# WR1D BLOCK DIAGRAM

QUANTA COMPUTER
<b>PAGE LIST</b>		
Size	Document Number	Rev
Custom	WR1D MAIN BOARD	3A
Date: Friday, August 25, 2006	Sheet	2 of 43

Size	Document Number	Rev
Custom	WR1D Main Board	3A

Title: **Callistoga Power&Strap 4/6**

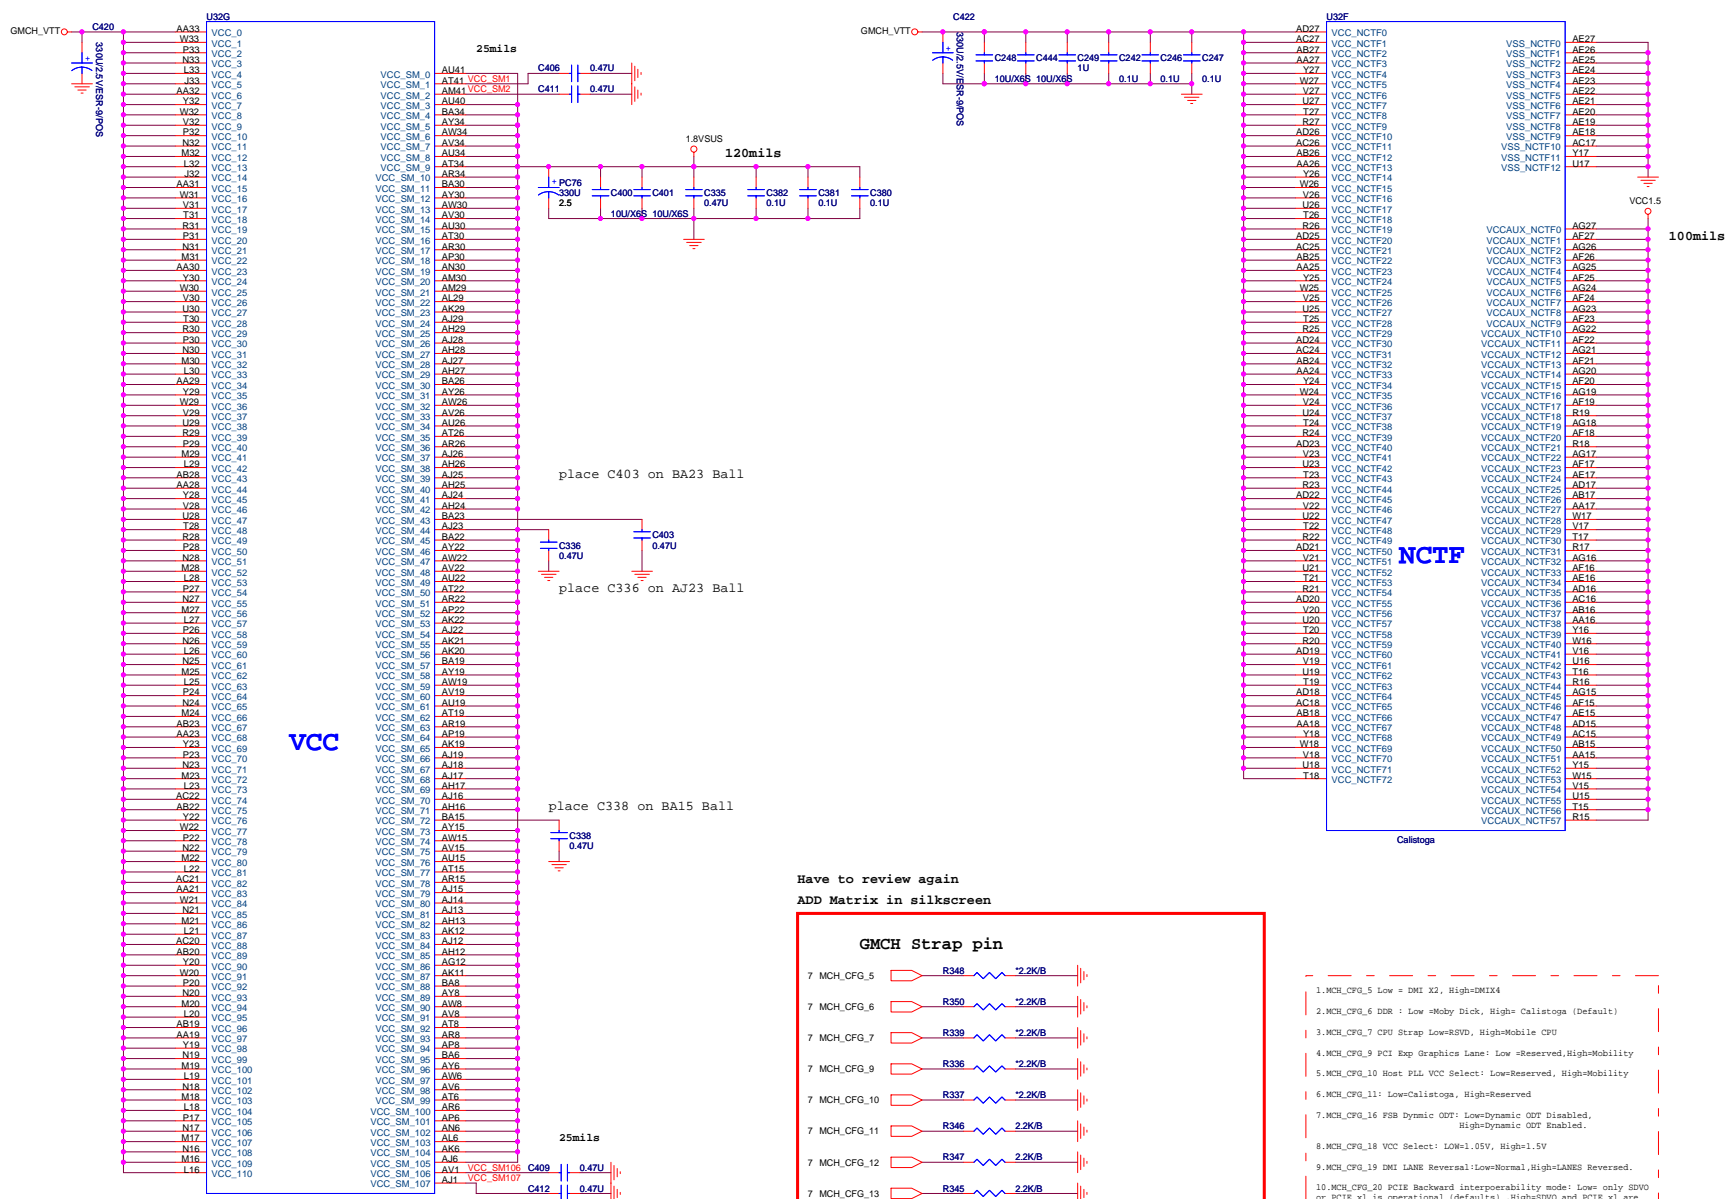
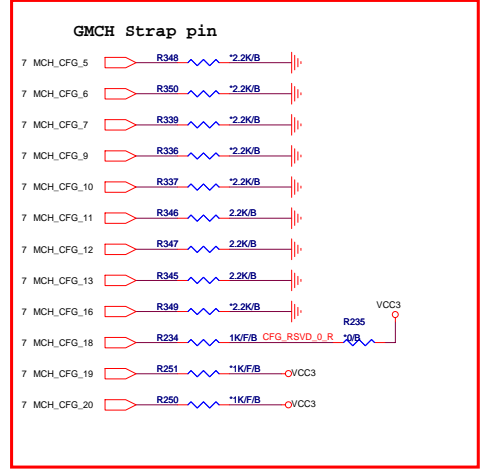
Have to review again  
ADD Matrix in silkscreen

**Calistoga Power 2 5/6**

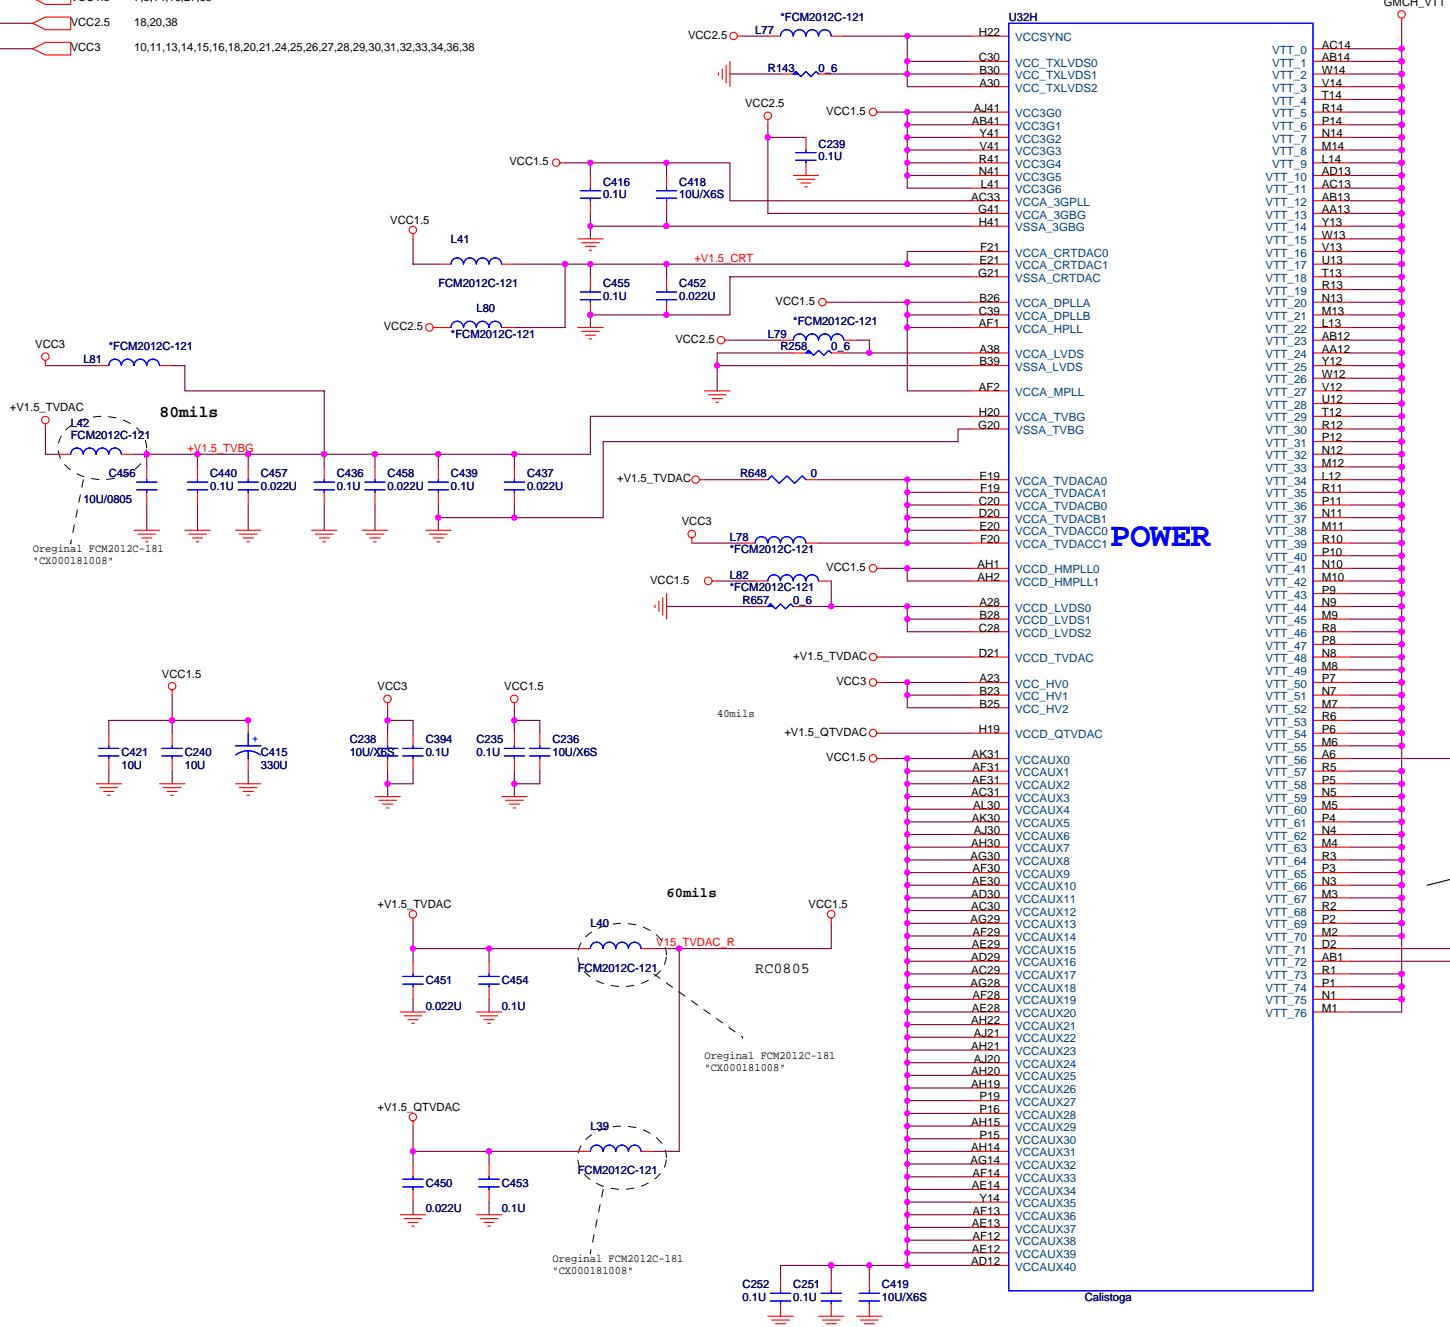
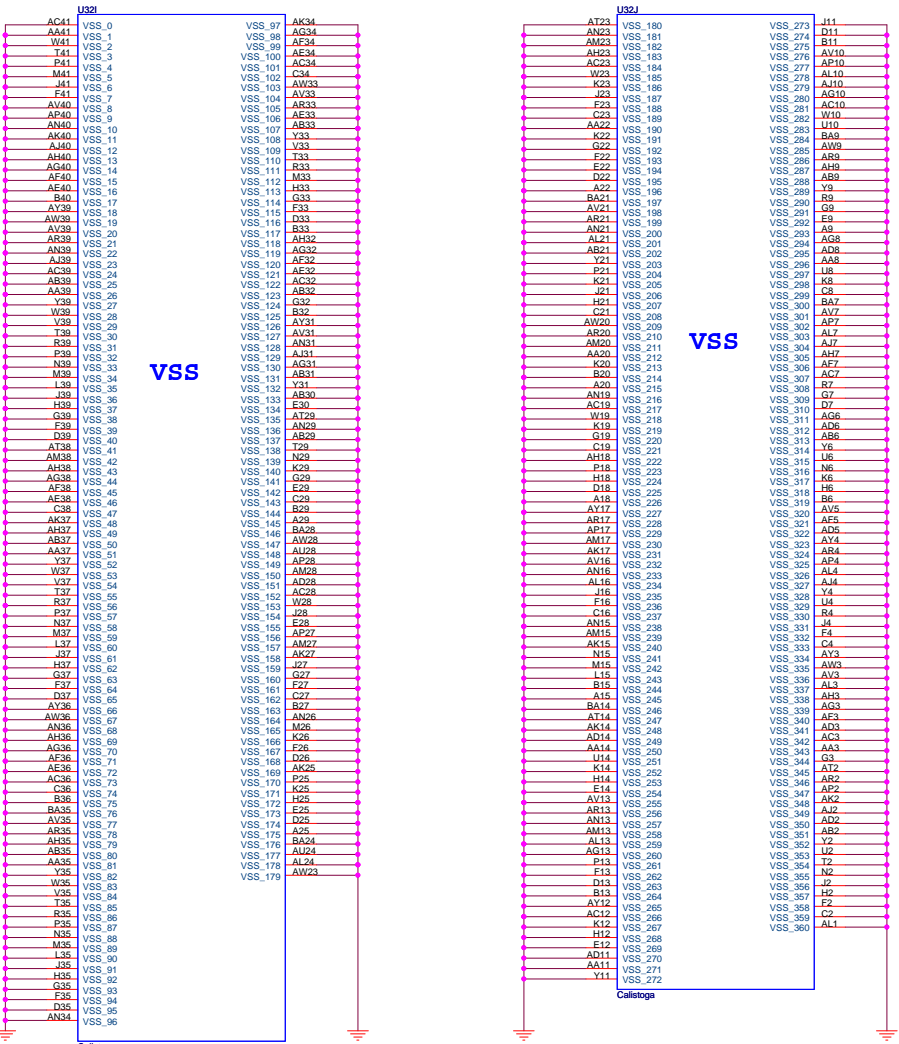
Shall Add more bypass caps for 1.05V

VTT\_56, VTT\_71 and 72 are attached with 0.1u separated .Checking

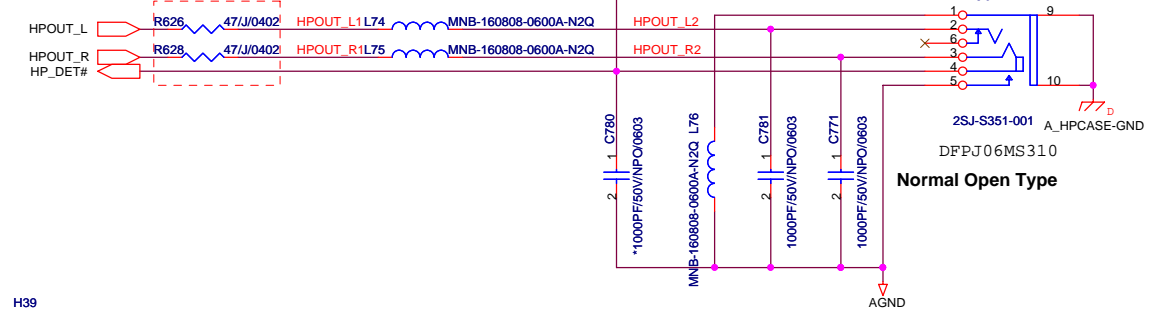
Change resistors dimension from 0603 to 0402 to prevent PCB bending cause solder and components crack issue!

### EXPRESS CARD SLOT

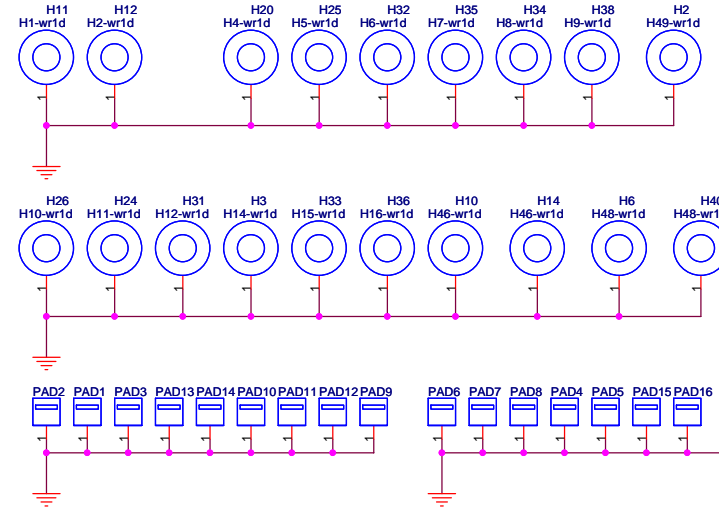
- Pin assignments for ExpressCard connector is wrong. Please change 7 pin from RSV#1 to SMBCLK. Please change 8 pin from SMBCLK to SMBDATA. Please change 9 pin from SMBDATA to 1.5V.
- Please apply 100K pull-up resistor to CPPE#.
- Please apply 100K pull-up resistor to CPUSB#.
- Please apply capacitor (0.1uF and 10uF) to +3.3V\_NC1, +3.3VAUX\_NC1 and +1.5V\_NC1 respectively.

Title: **USB&TPM&FELICA&FINGER-PRINT**

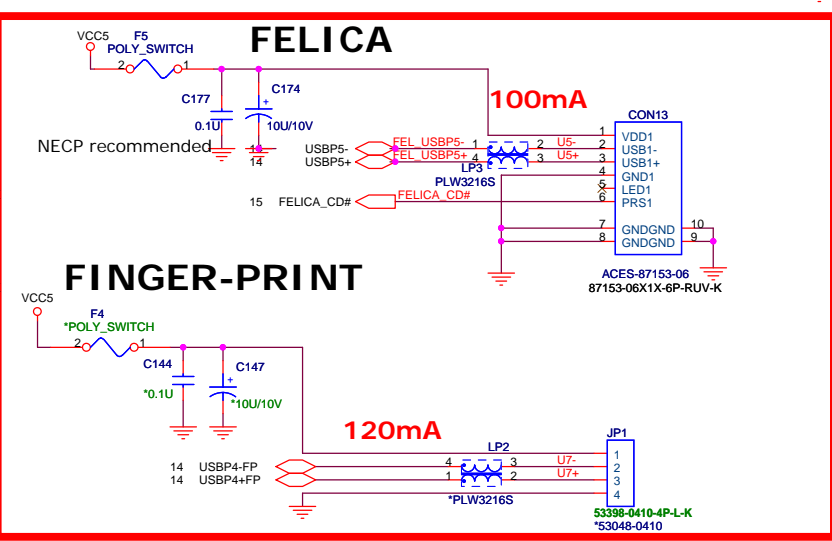
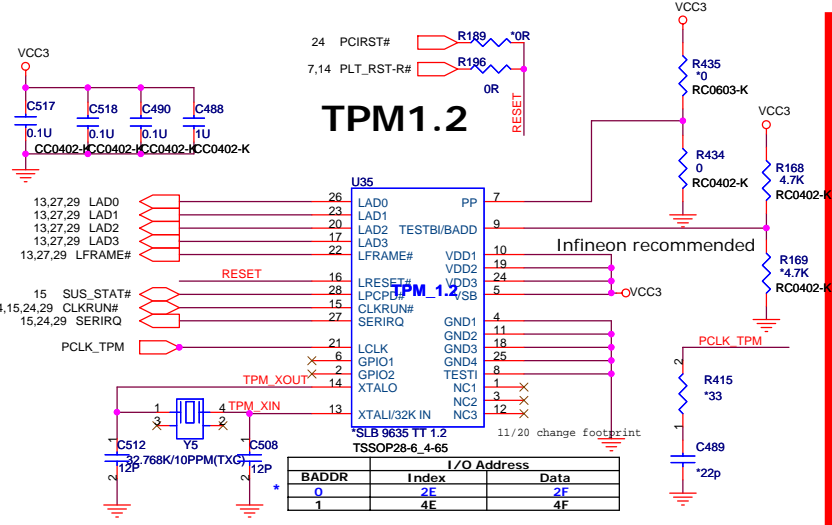
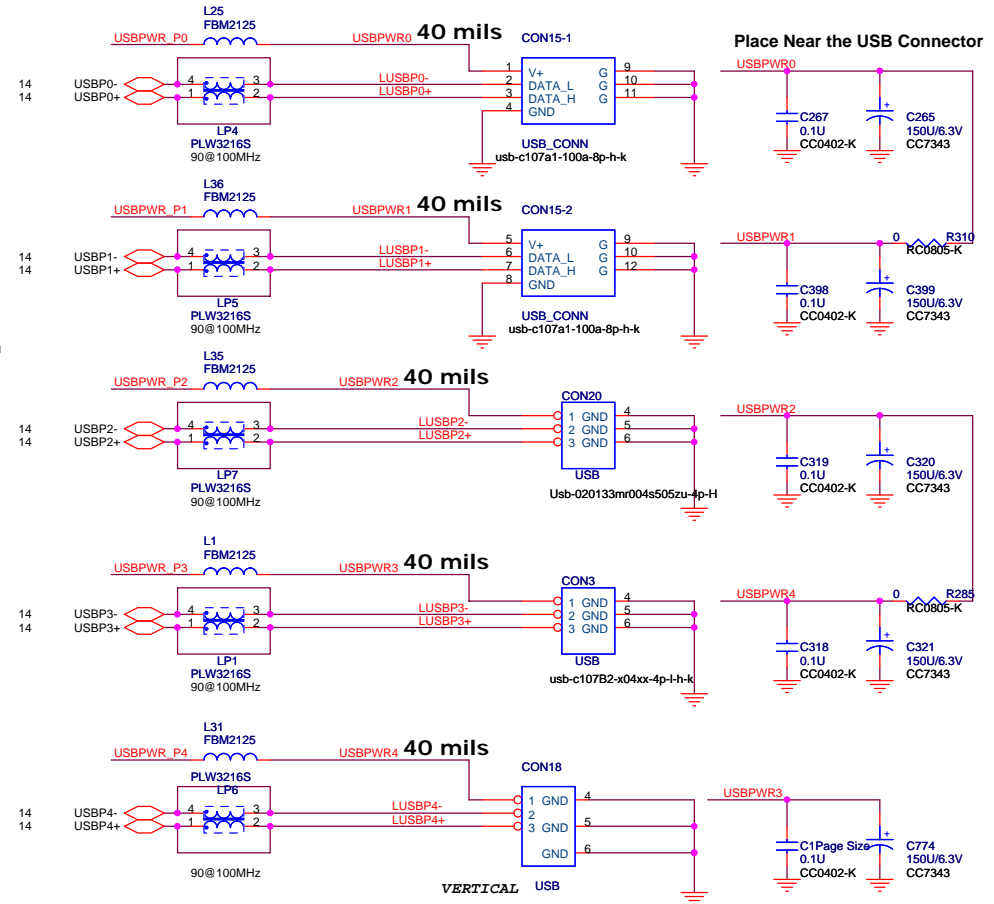
NECP request to add self power protection

### HDMI PORT

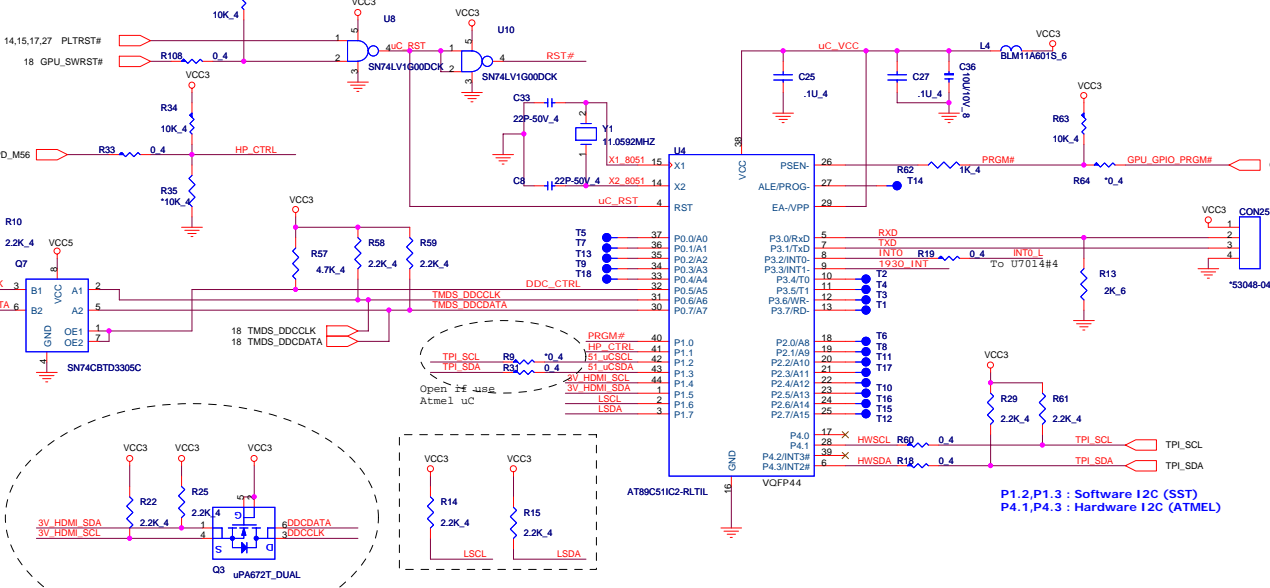
Mount R63, keep R64 NC at the beginning  
Remove R63, mount R64 after VBIOS  
add PRGM# function.

Sillicom request need to add this MOSFET to avoid ATME1 latch up

HDMI\_SDA & HDMI\_SCL capacitance MUST less than 50PF
